## Tech Bulletin: Hydronic Models

P/N: TB14.003

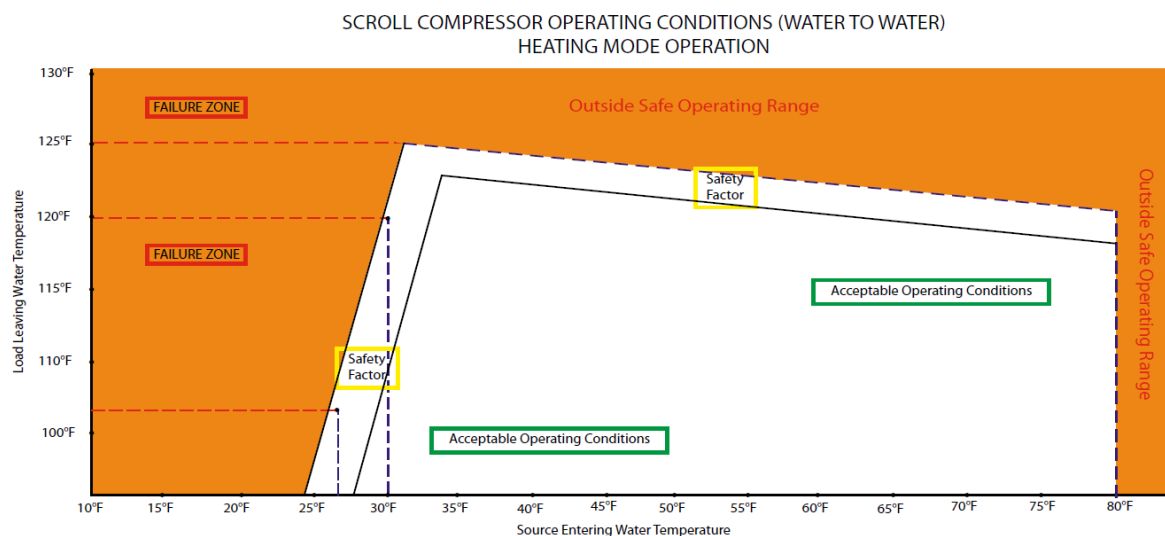
The illustration below shows the parameters which are safe for compressor operation. Based on the leaving load water of 120°F, the loop would have to maintain 35°F to operate within the acceptable operating conditions for the compressor. Once your loop temperatures drop below 35°F, the acceptable leaving load temperature drops below 120°F. If you are designing loops for 30°F, the recommended leaving load temperature is 110°F.

The obvious correlation is that the warmer the **Source Entering Water** temperature, the hotter the **Load Leaving Water** temperature. Refrigerant R410A can only handle up to 120°F leaving load water temperature before placing the compressor at risk.
